ADDENDUM No. 2

RFP No. 22-82

S. Main Street Water Main Replacement and Resurfacing Project

SCALE PLAN: NOT TO SCALE
DRAWING NO. 2020-038-14

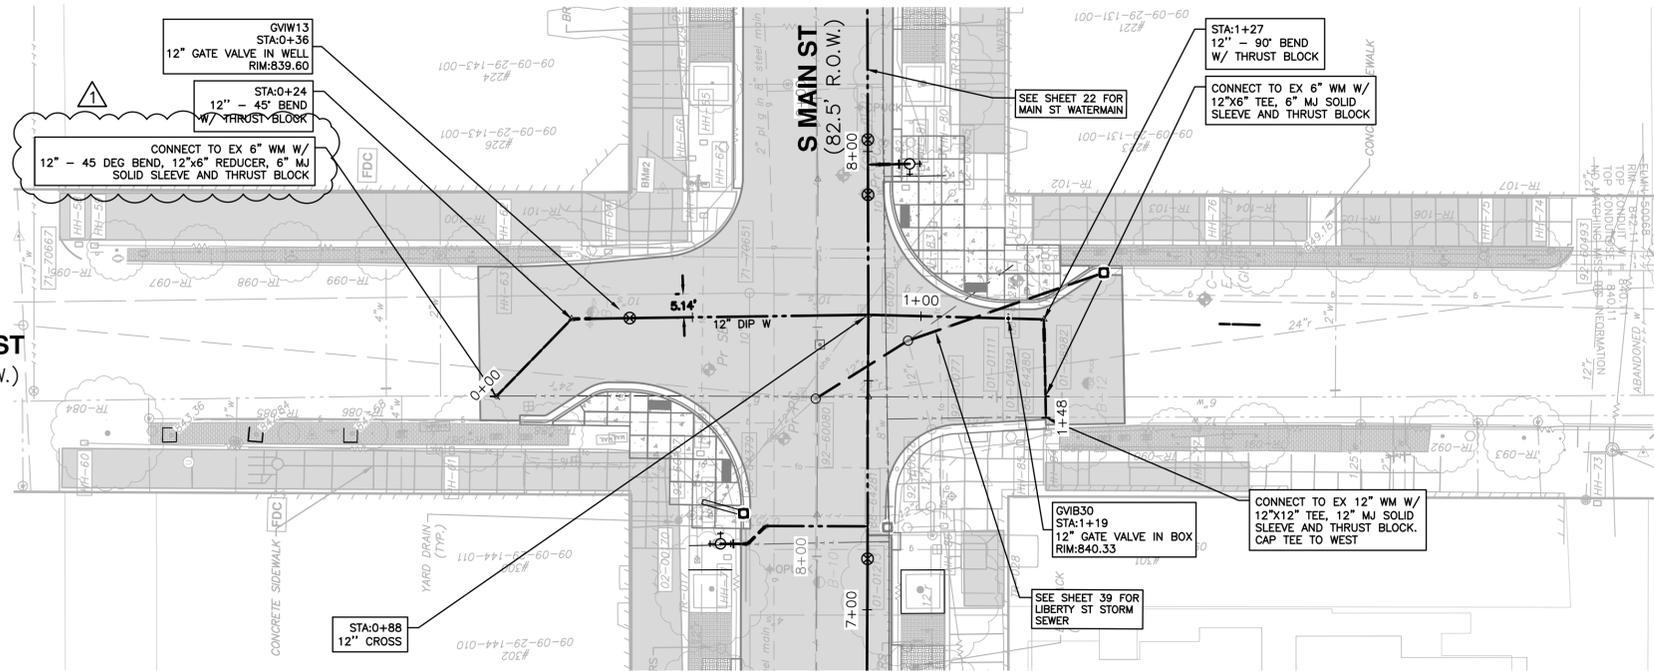
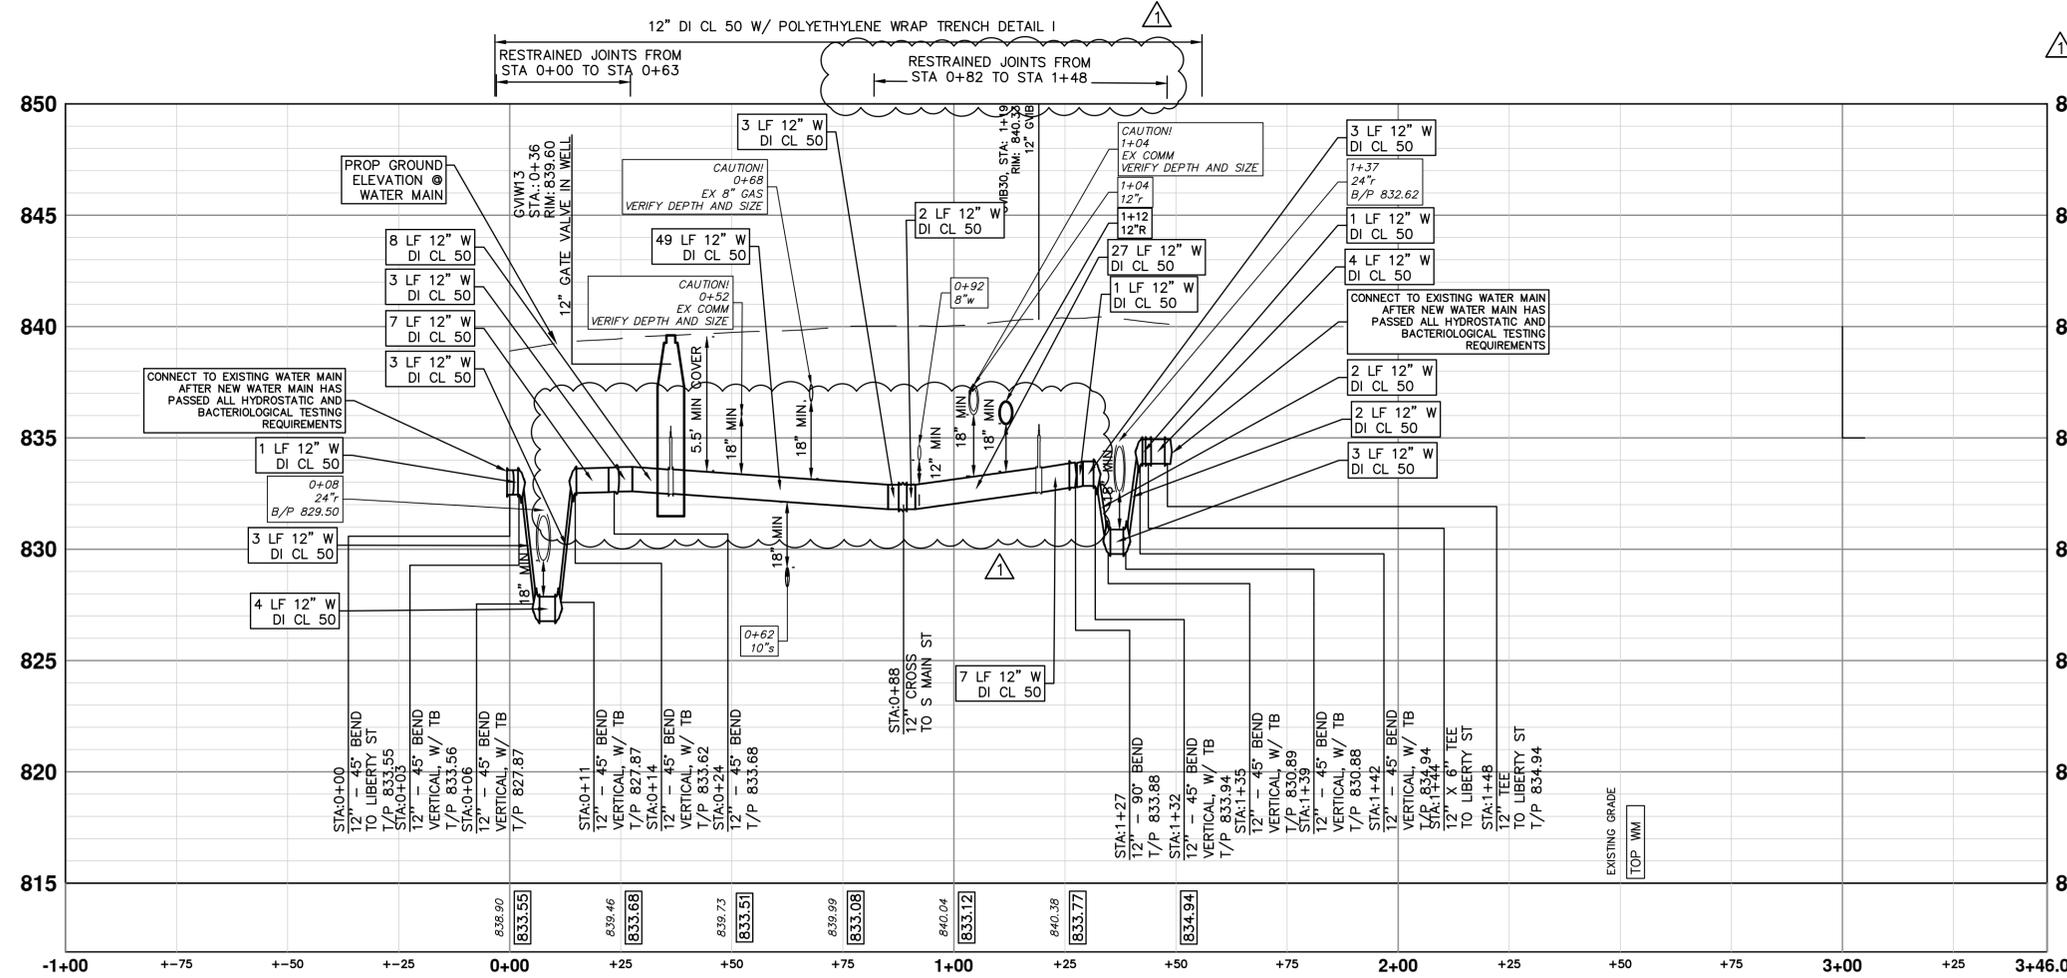
- As updated herein:
Replace “Huron” with applicable intersection located on plan sheet (William, Washington, Liberty).
- Plan Sheet 14
- Revised aggregate base and subbase notes to include correct pay item.

DRAWING No. 2020-038-27
SHEET No. 27 OF 80

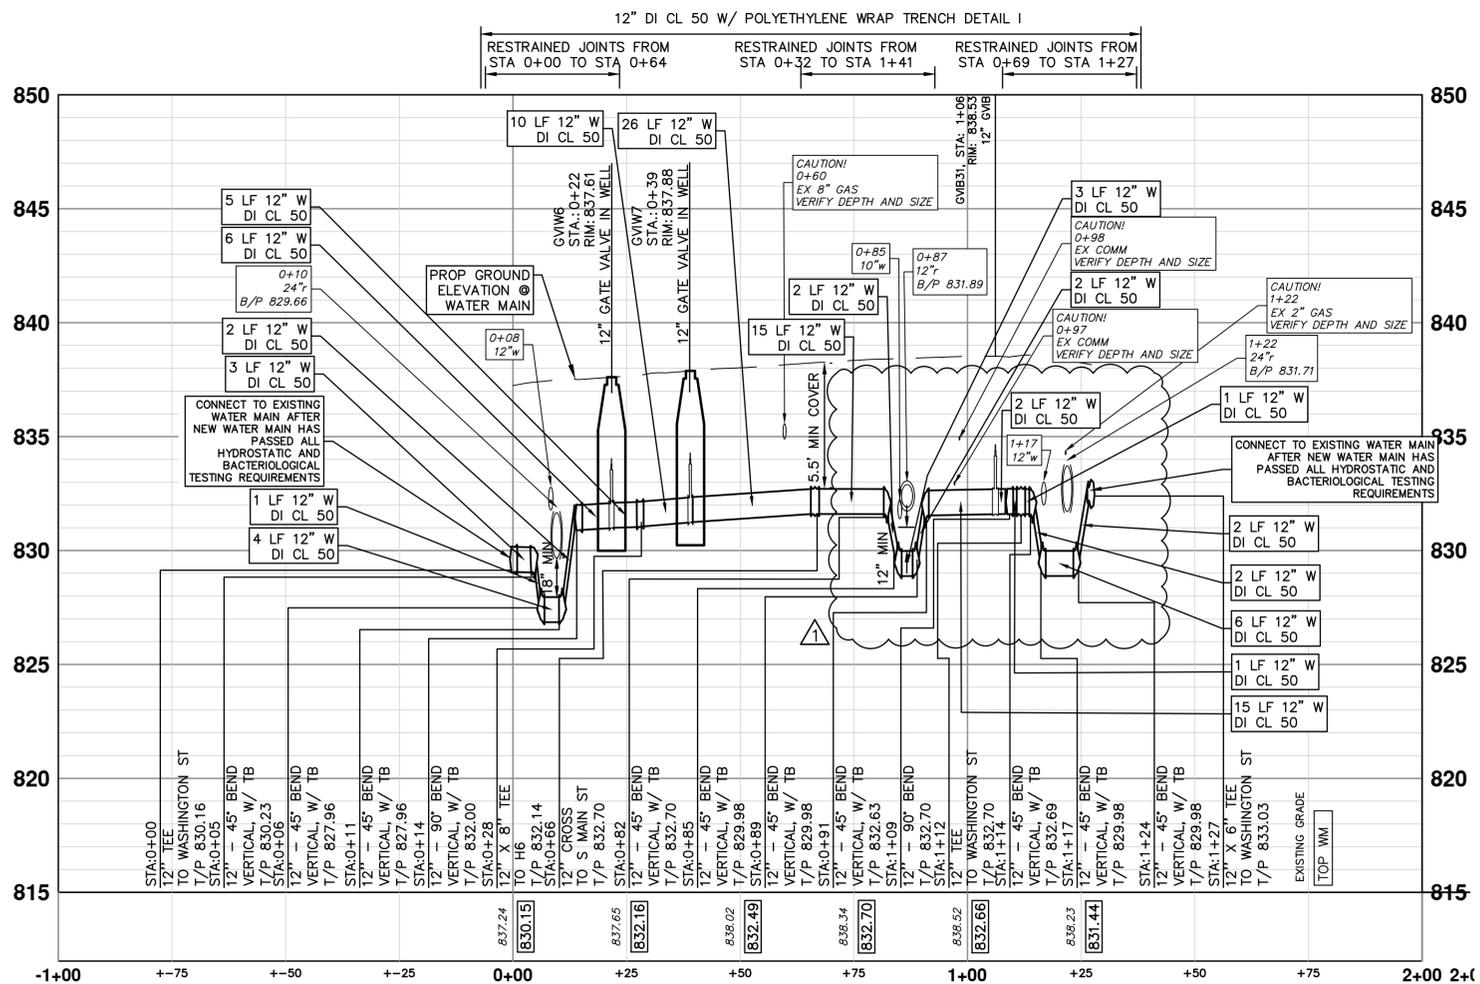
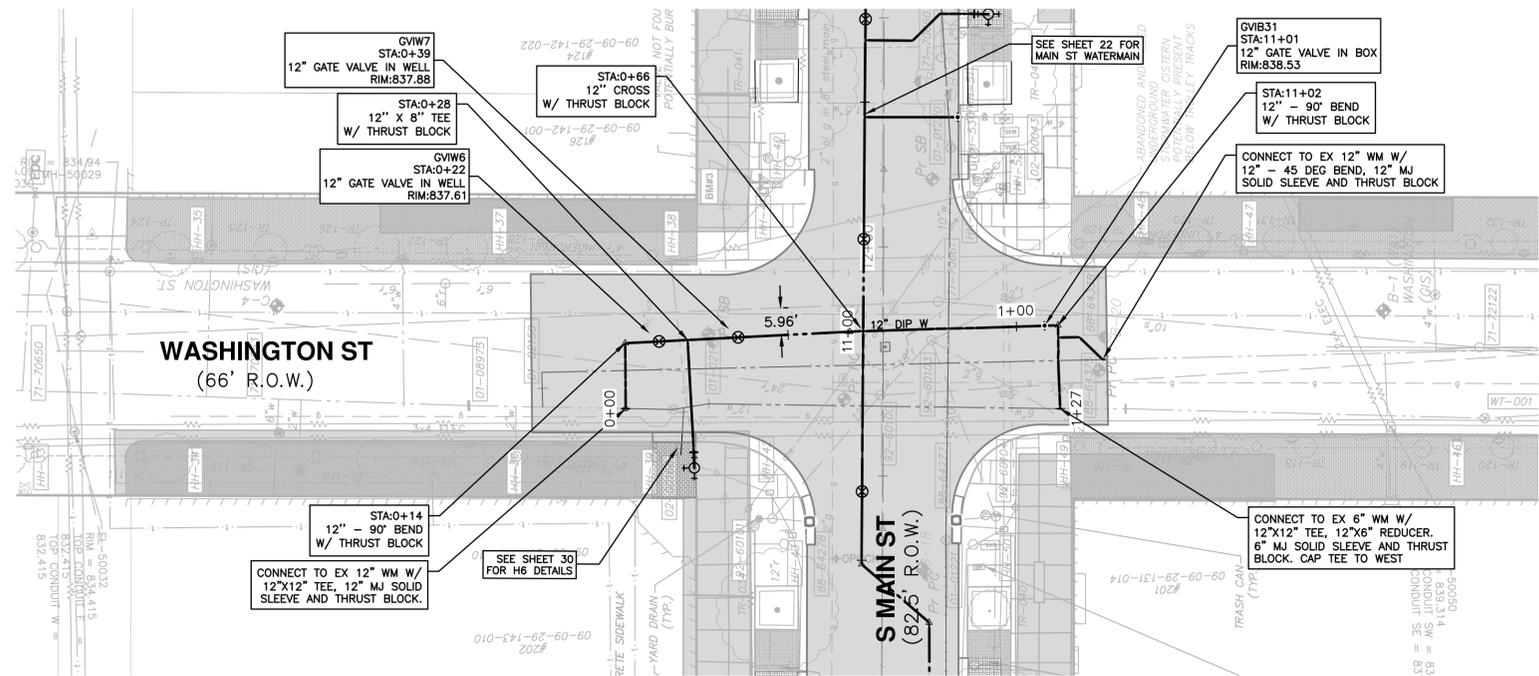
- Plan Sheet 27
- Connection to existing watermain on west side of Liberty was corrected to reflect existing 6-inch watermain.
 - Watermain lowering between STA 0+82 and STA 0+98 was eliminated

- Restrained joint length was changed to reflect the elimination of the lowering
- Plan Sheet 28
- Elevation of existing watermain crossing was corrected at STA 0+85 and 1+17. Note that the exact elevation of the existing water main crossing must be verified by the contractor. Existing water main will remain live throughout installation of new watermain.

DRAWING No. 2020-038-29
SHEET No. 29 OF 80

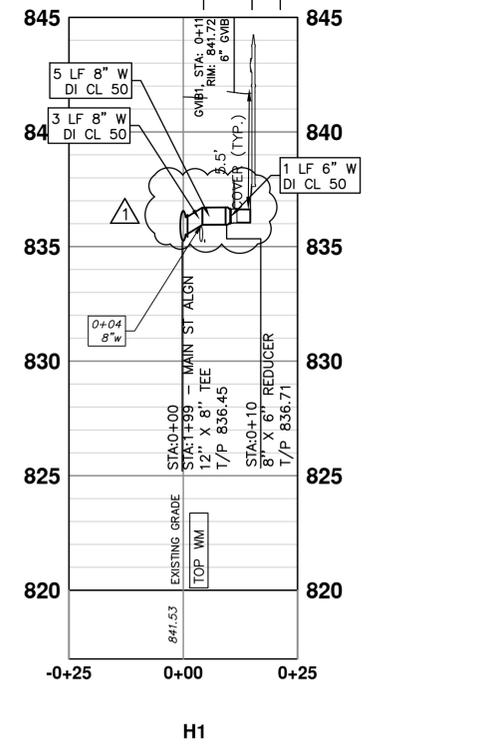
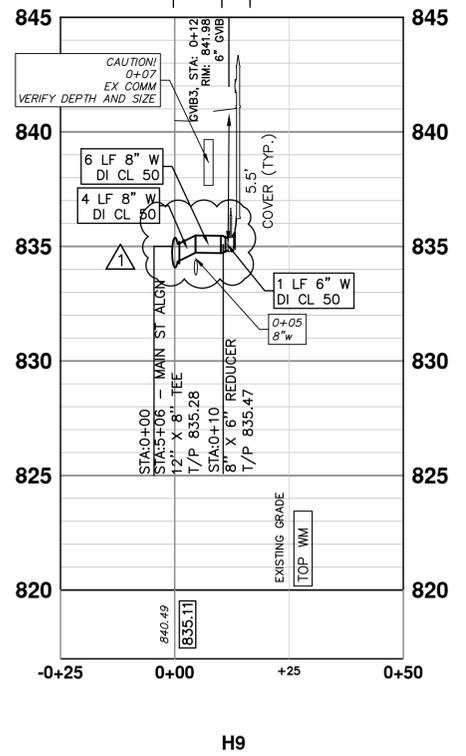
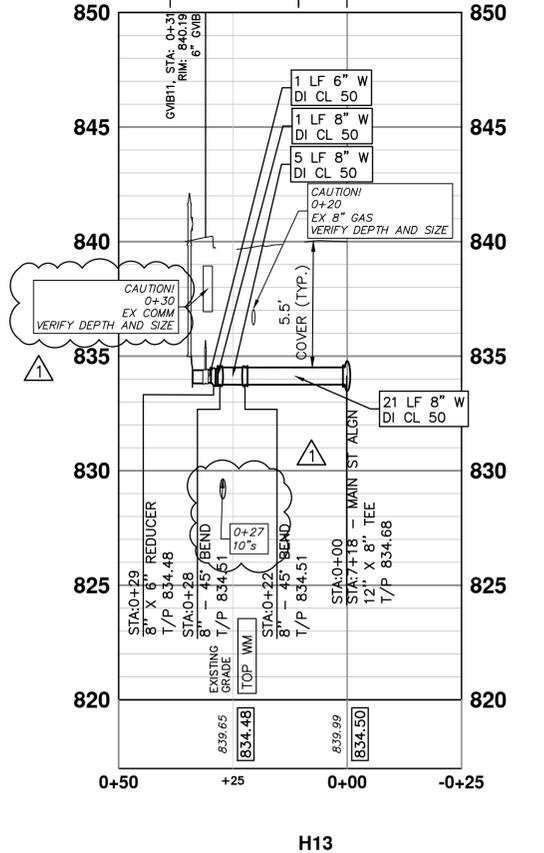
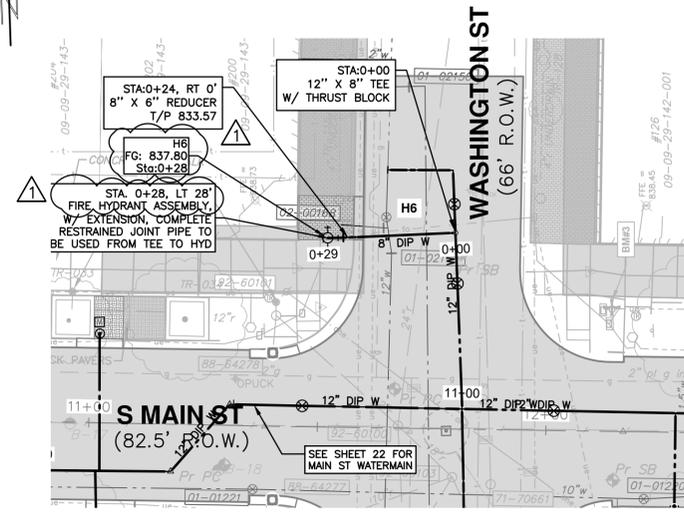
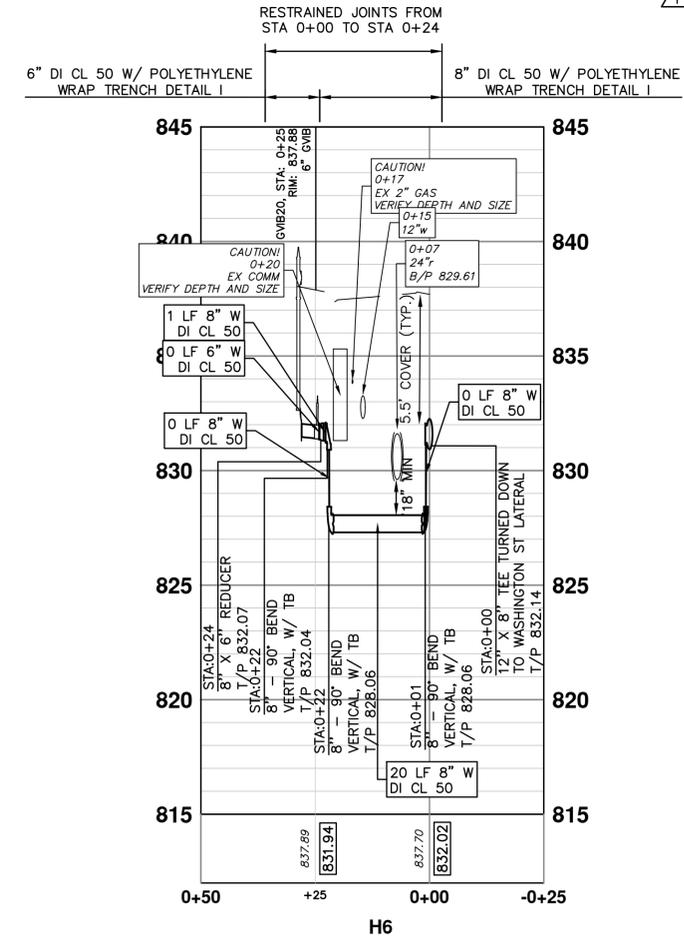
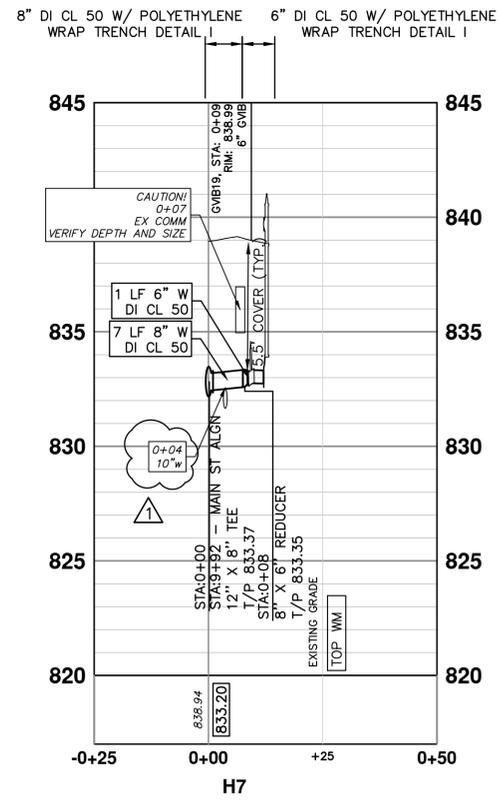
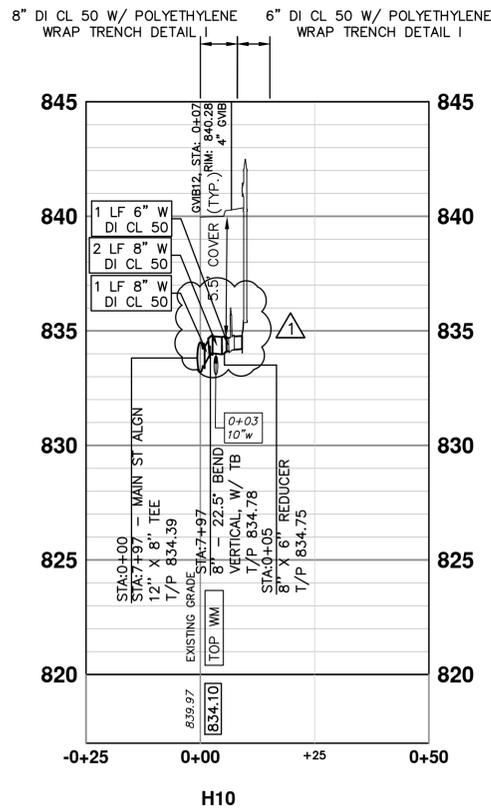
- Plan Sheet 29-30
- Finish grade elevations on hydrants were corrected
 - H6, H10 and H13 were shifted horizontally for ease of constructability
 - Elevation of existing watermain crossing was corrected. Note that the exact elevation of the existing water main crossing must be verified by the contractor. Existing water main will remain live throughout installation of new watermain.

- Utility crossings corrected at H13. Note that the exact elevation of the existing utility crossings must be verified by the contractor.
- Plan Sheets 22-38

SHEET NO. 32 OF 80

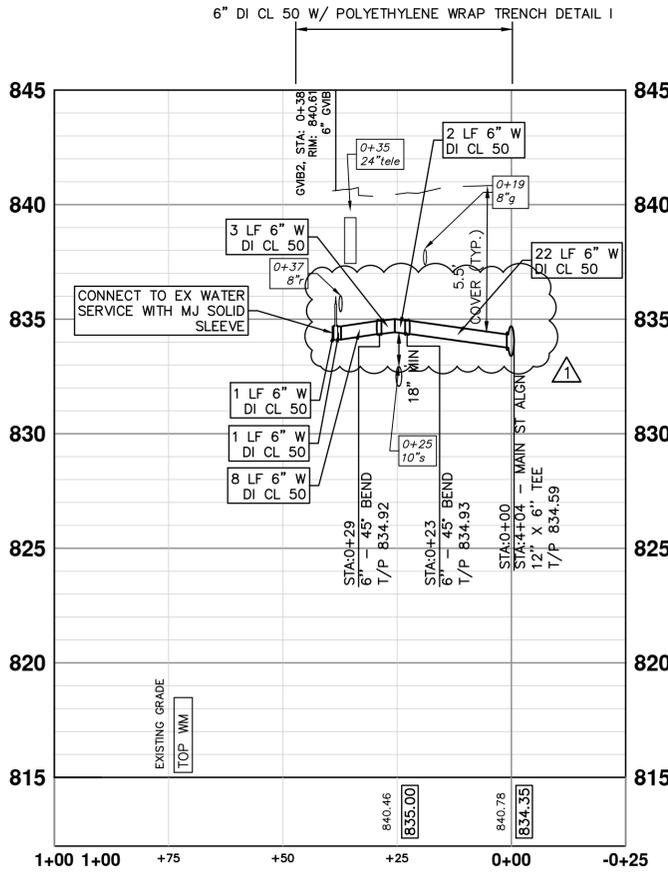
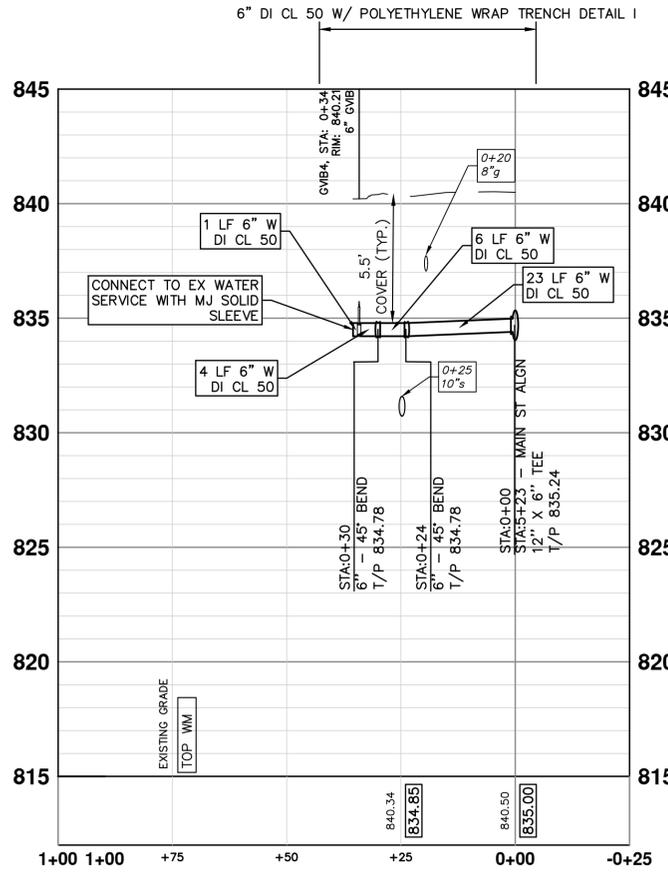
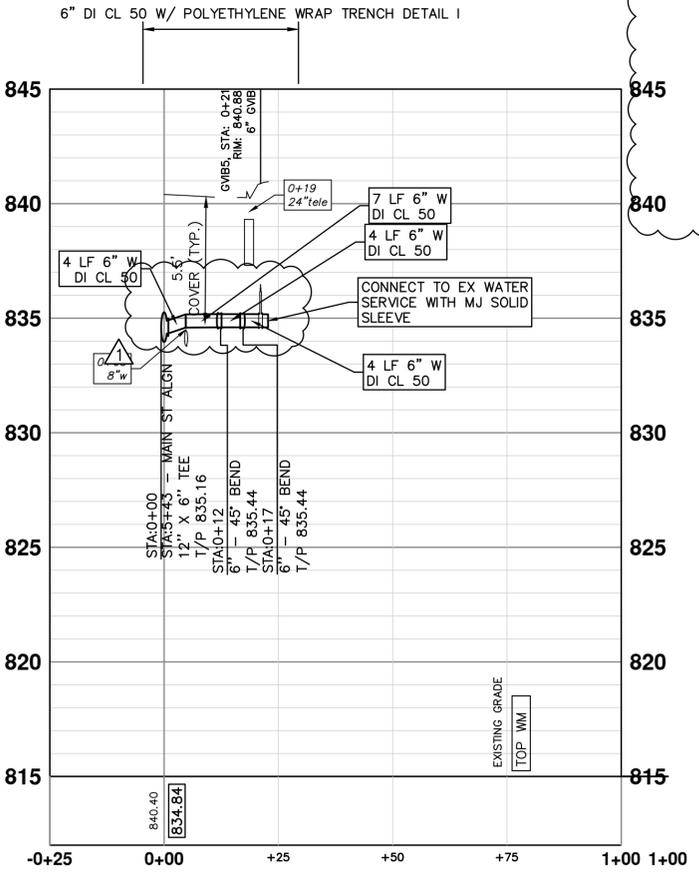
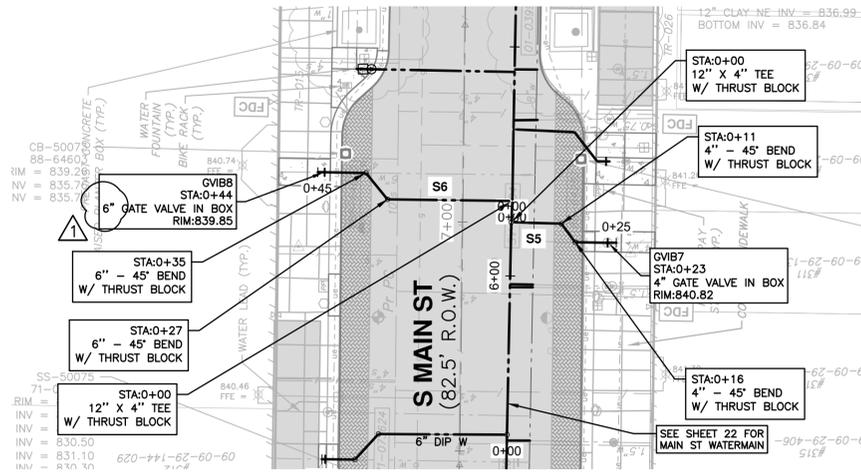
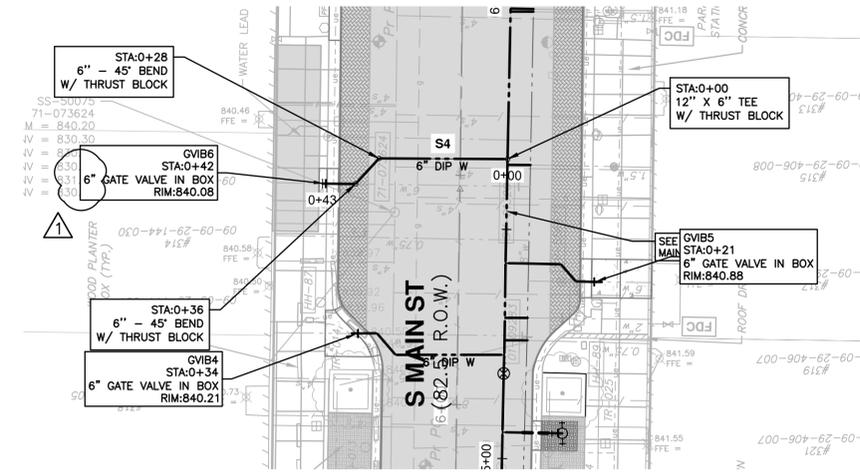
- Plan Sheet 32
- S1 lowering from STA 0+16 to STA 0+34 was eliminated.
 - S3 lowering from STA 0+00 to STA 0+09 was eliminated
- Plan Sheet 33
- S5 lowering from STA 0+00 to STA 0+09 was eliminated
